# TOWN AND COUNTRY PLANNING (SCOTLAND) ACTS - PLANNING APPLICATION: 2015/0305/DET. ERRECTION OF OFFICE ACCOMODATION SAWMILL BALLIEMEANOCH, STRACHUR, ARGYLL AND BUTE, PA27 8DW.

Following receipt of the SEPA response with respect to the above project we are pleased to provide the following comments and additional information.

Figure 1: Alternate emergency access and egress from the site to the A815.

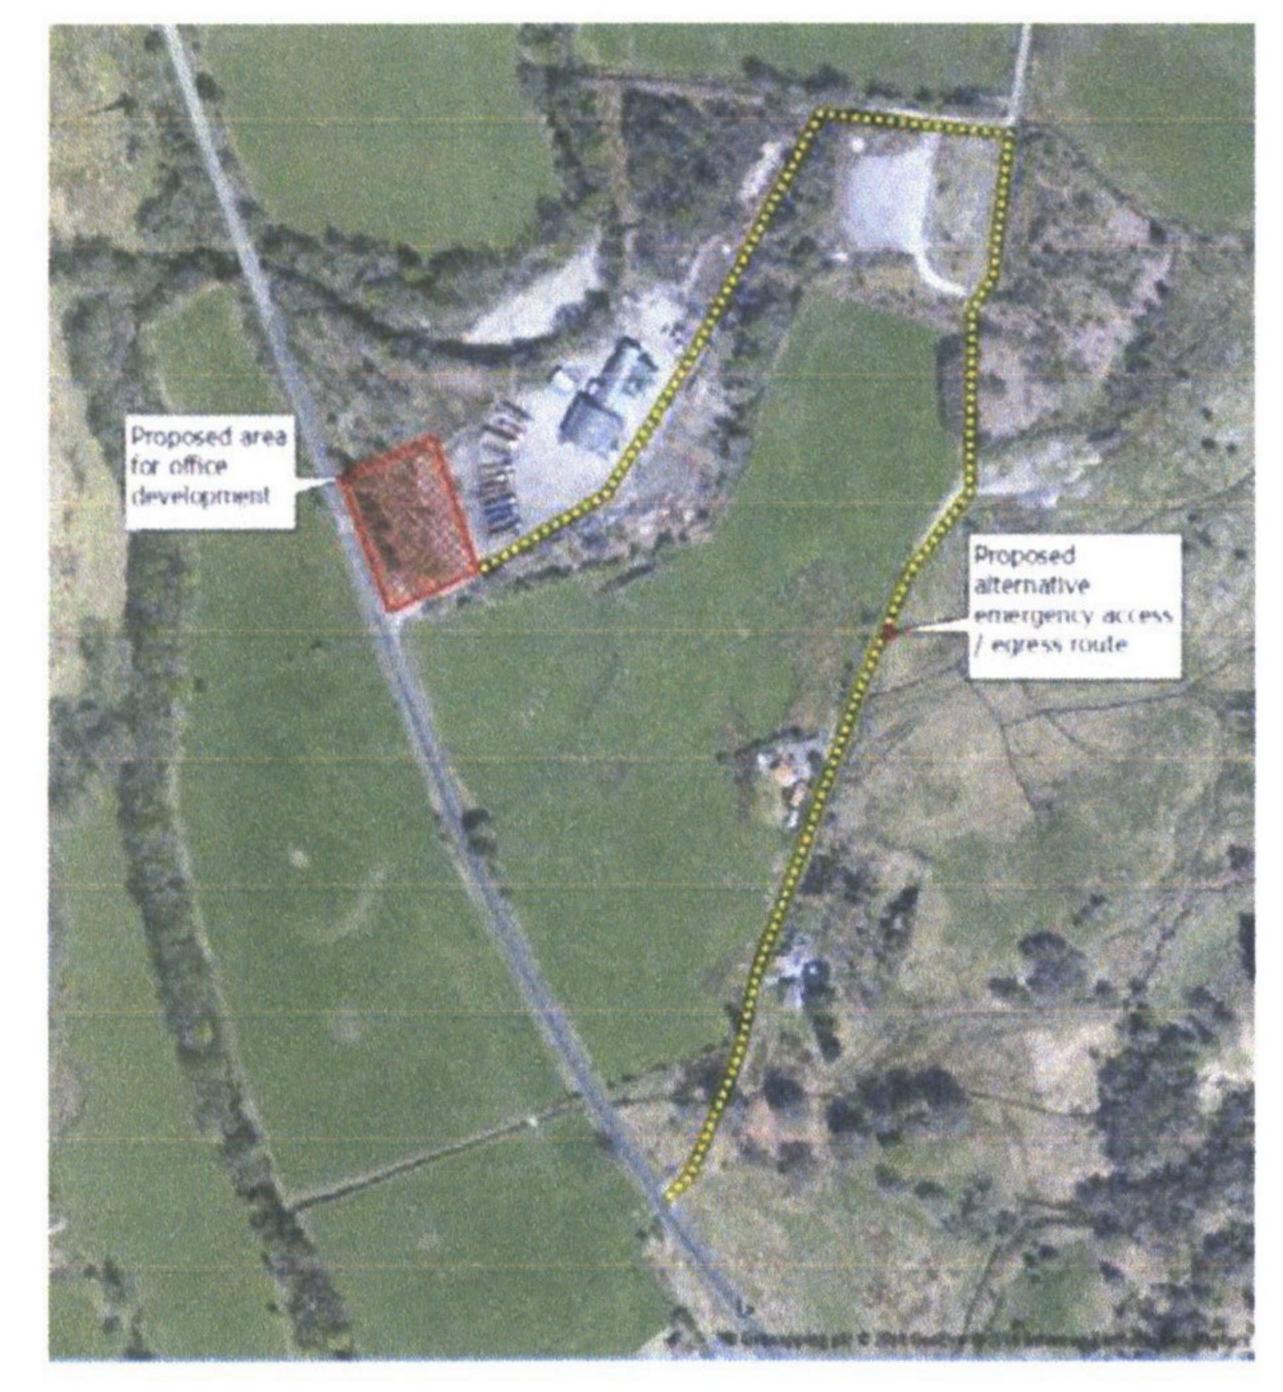
Within the SEPA response, in sub-section 1.8, SEPA notes that there are concerns over emergency access and egress from the site, even following re-grading works to ensure a maximum 300mm water depth is not exceeded over the site entrance. The SEPA proposal to elevate the site entrance to a level above the 1 in 200 year peak flood water level including an allowance for freeboard is unfeasible. The adoption of a 300mm maximum water depth is the typical council requirement for vehicular access of emergency vehicles within a flooded area. In addition to this, there is also an alternate emergency access and egress from the site via the shared access road that runs through the site. Figure 1 below shows the alternative route.
